**RELEASED FOR  
 FABRICATION / INSTALLATION**  
 PPPL Drafting:

Oak Ridge National Laboratory managed for the DEPARTMENT OF ENERGY under U.S. GOVERNMENT contract DE-AC05-00OR22725 UT-BATTELLE, LLC, Oak Ridge, Tennessee PROJECT NAME						
NATIONAL COMPACT STELLERATOR EXPERIMENT VACUUM VESSEL PERIOD INSPECTION AND LEAK CHECK ASSEMBLY						
VERSION NO.	PLANT	BLDG	FL	SHT OF	TYPE	CLASS
5	X-10	5700	3	2 19	A	U
RELEASE LEVEL		SE120-004			REV	
Fabrication					2

TYPICAL PORT 17A AND 17B SECTION PORT17-PORT17

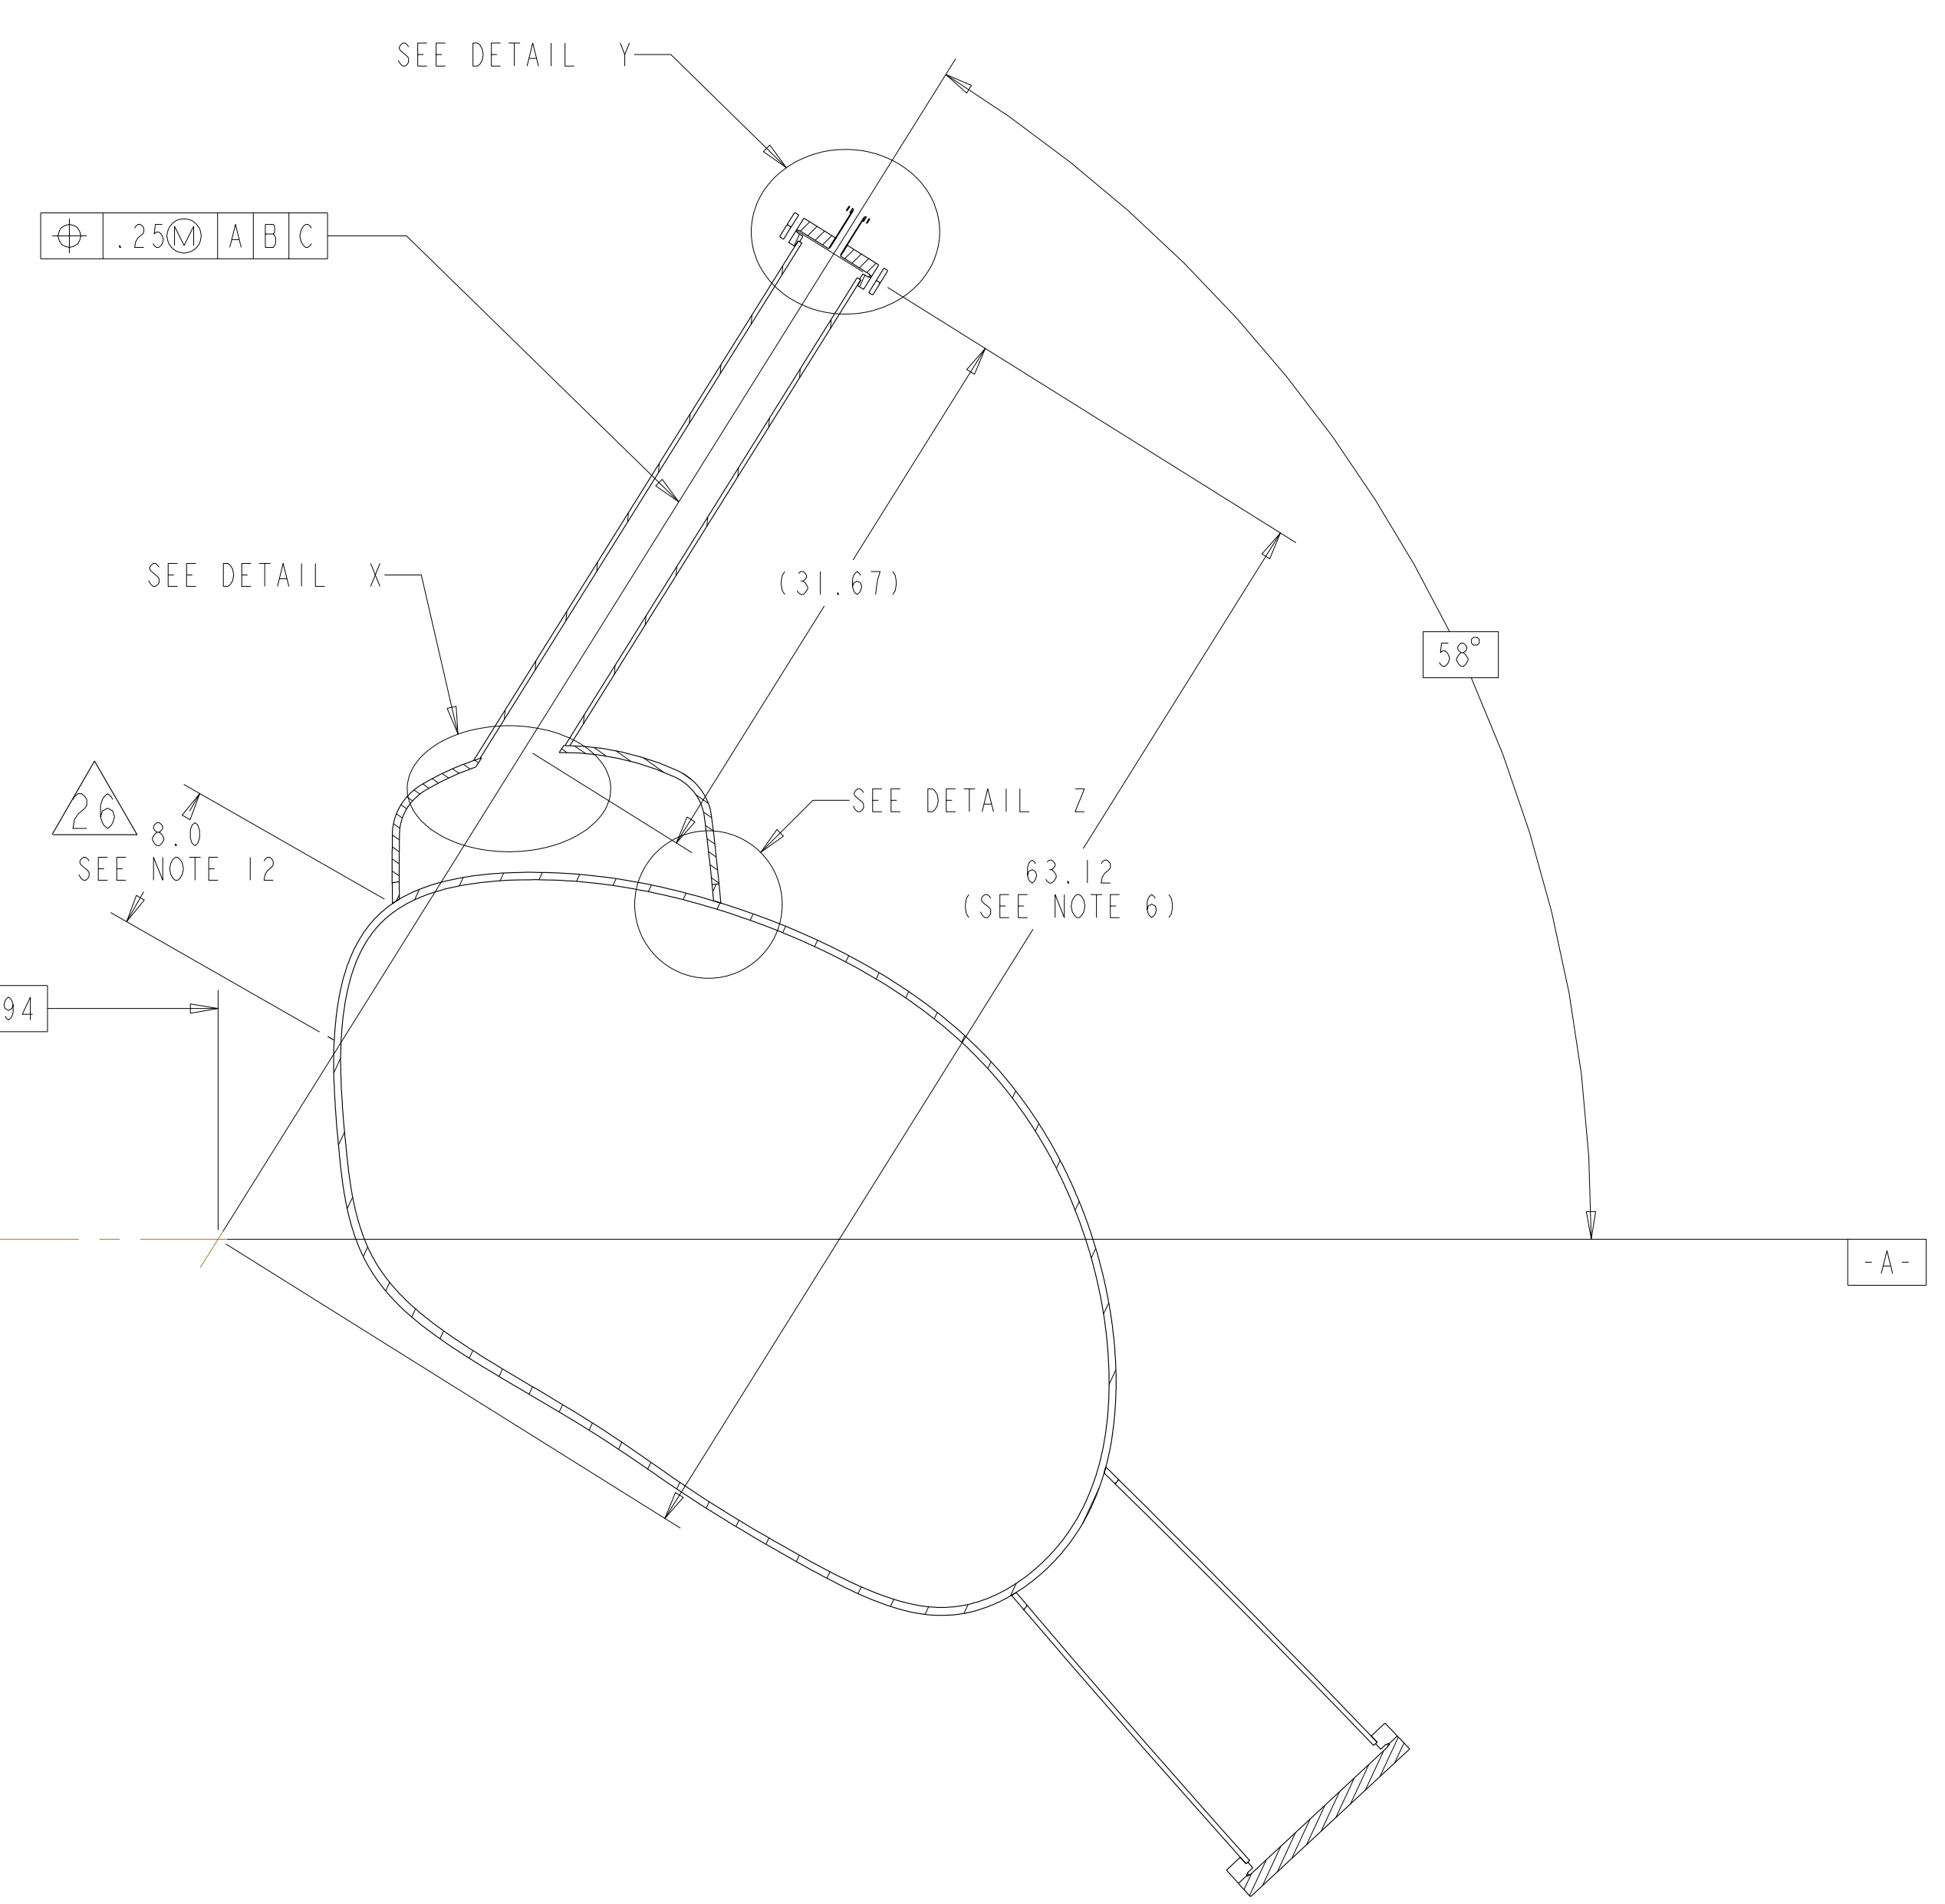
**ECN-5082.** Requirement originally included grooves to facilitate leak checking by vendor. However, vendor elected another means of leak checking and therefore the grooves are no longer required. Specifically, this ECN eliminated the leak checking groove on SE121-014 (Rev 1-c) and SE1221-091 (Rev 0-a). Additionally, this ECN added a missing weld symbol to SE121-004 (Sheets 4 through 19) for joining the port extensions to the vessel (Rev 2-d).  
 (See ECN-5082 for details)

**Rev 2-e: ECN-5021 (RFD-12-017) approved alternate methods for welding the port extensions to the VVSA (See ECN-5021 for details). - Only applicable to VVSA #3 - VVSA #1 and #2 covered by NCR 19464.**

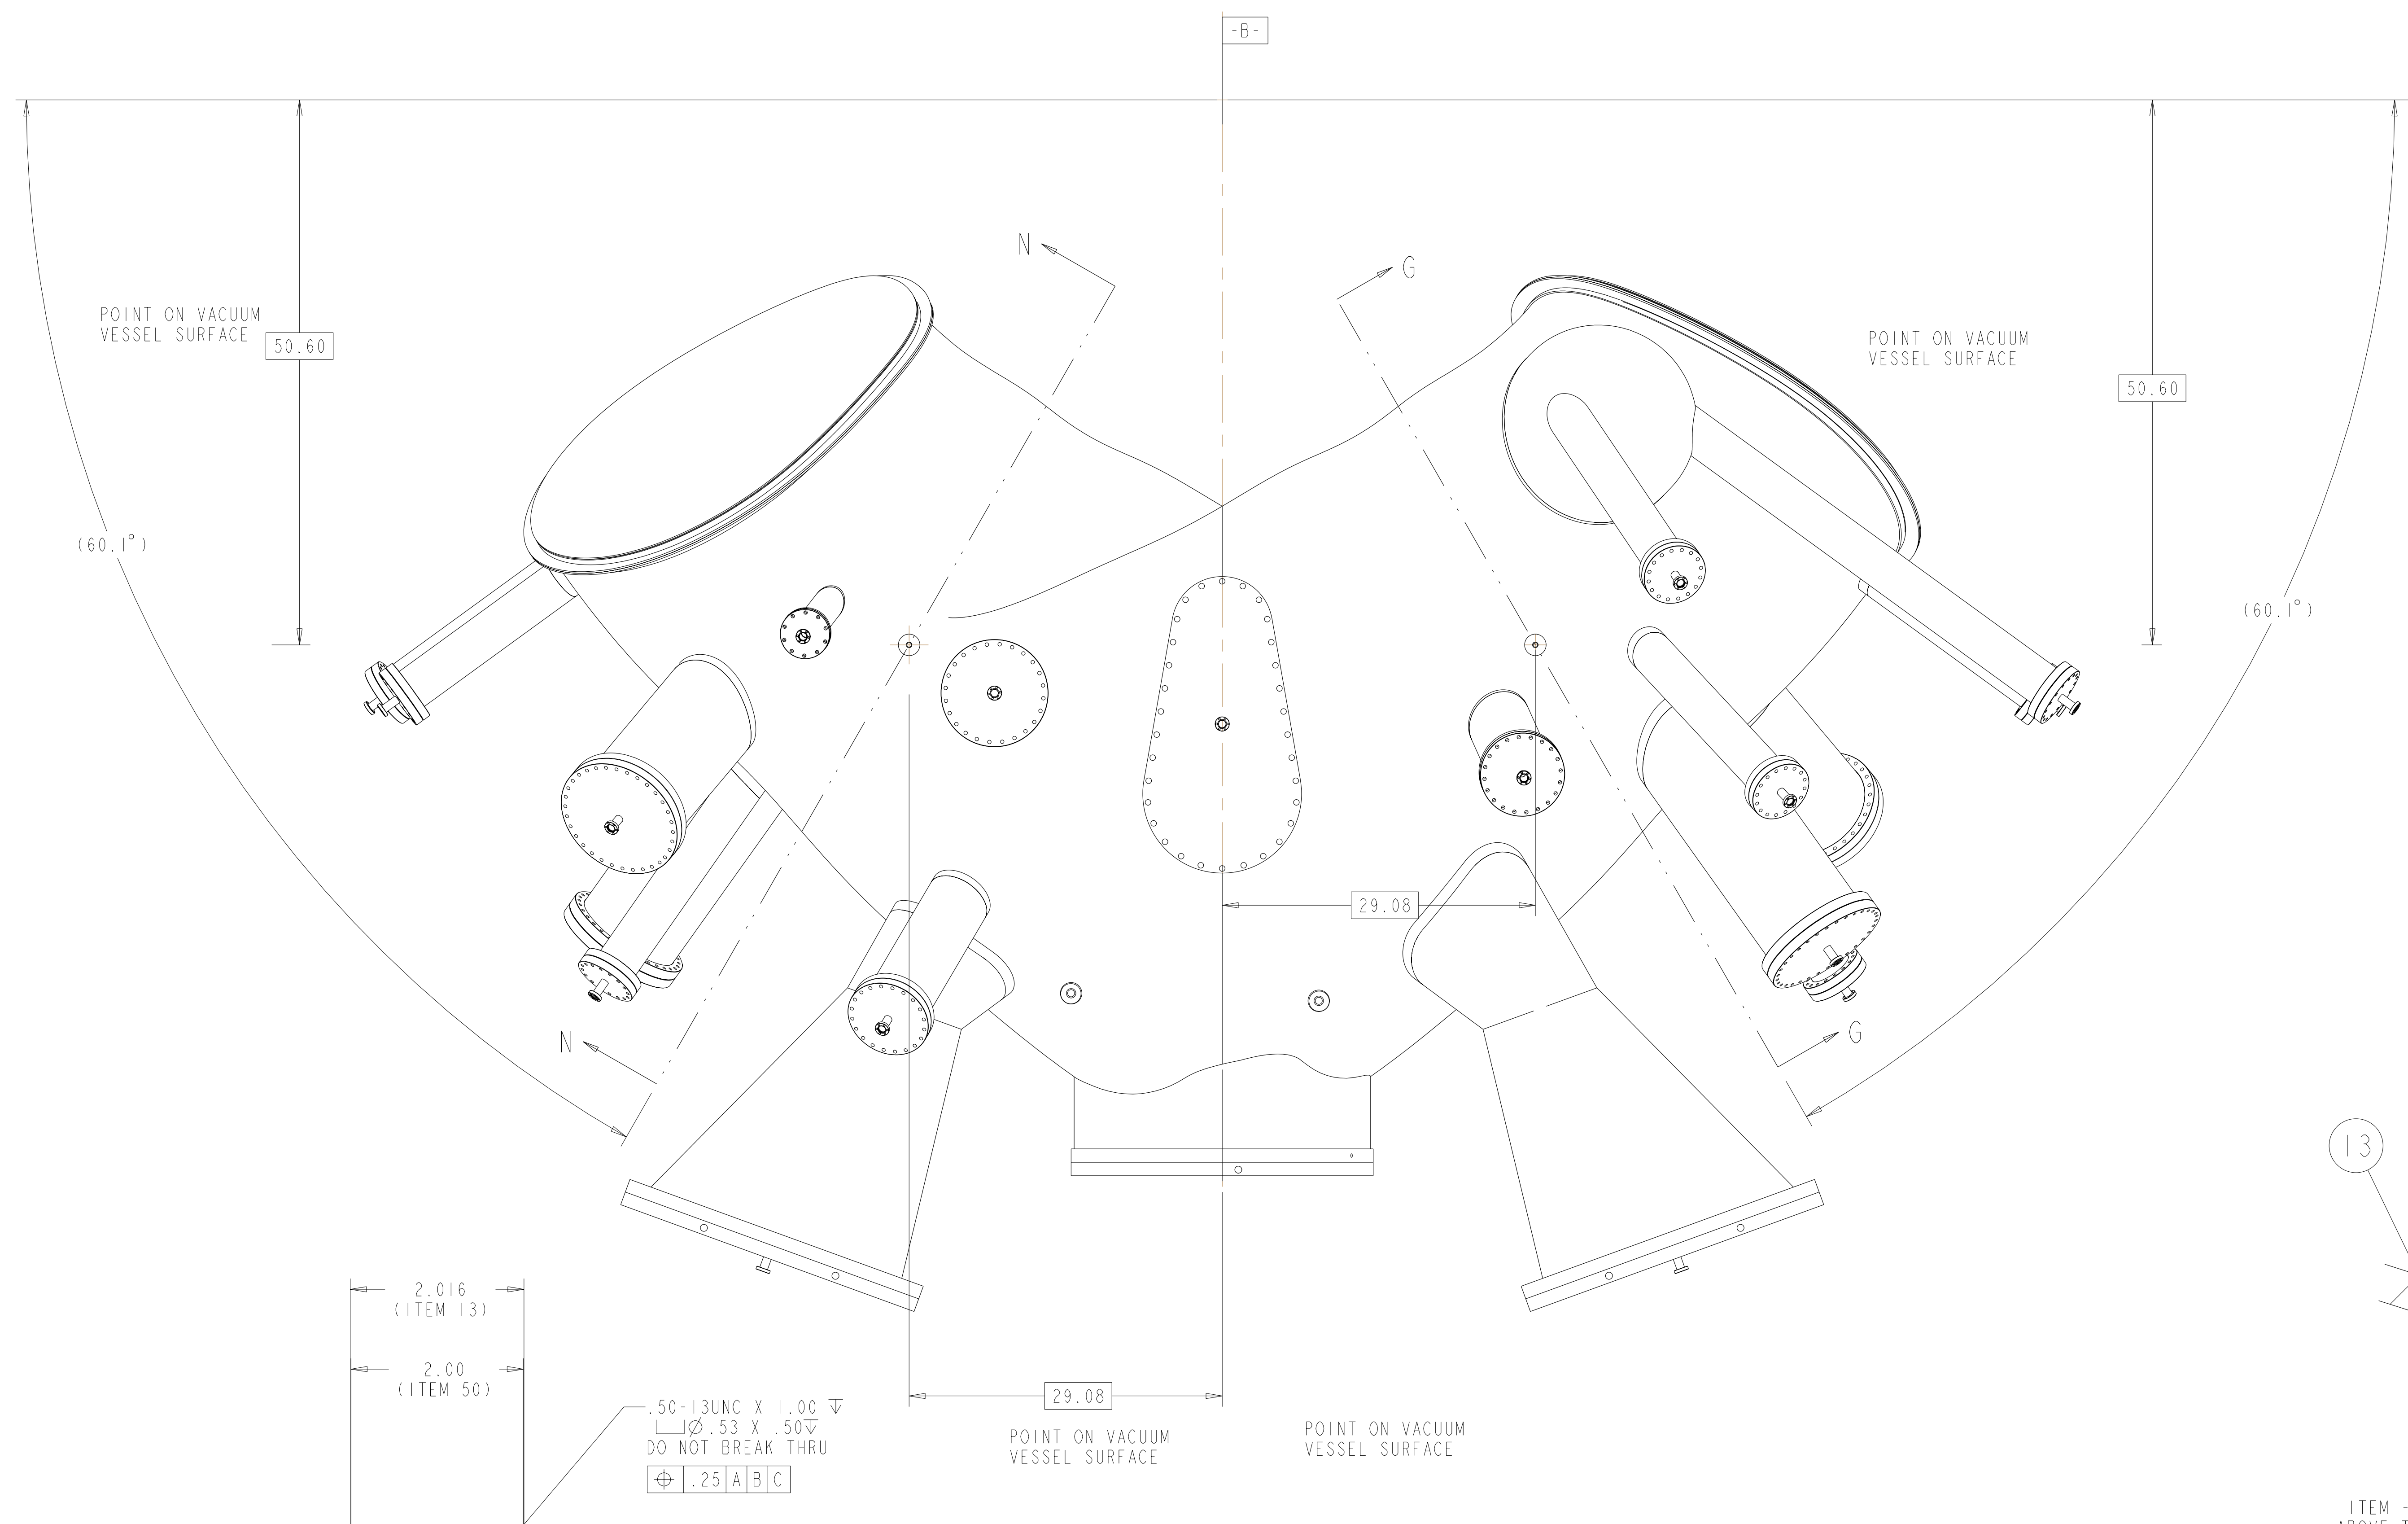
**Rev 2-e: ECN-5021 (RFD-12-017) approved alternate methods for welding the port extensions to the VVSA (See ECN-5021 for details). - Only applicable to VVSA #3 - VVSA #1 and #2 covered by NCR 19464.**

**ECN-5082. Requirement originally included grooves to facilitate leak checking by vendor. However, vendor elected another means of leak checking and therefore the grooves are no longer required. Specifically, this ECN eliminated the leak checking groove on SE121-014 (Rev 1-c) and SE1221-091 (Rev 0-a). Additionally, this ECN added a missing weld symbol to SE121-004 (Sheets 4 through 19) for joining the port extensions to the vessel (Rev 2-d). (See ECN-5082 for details)**
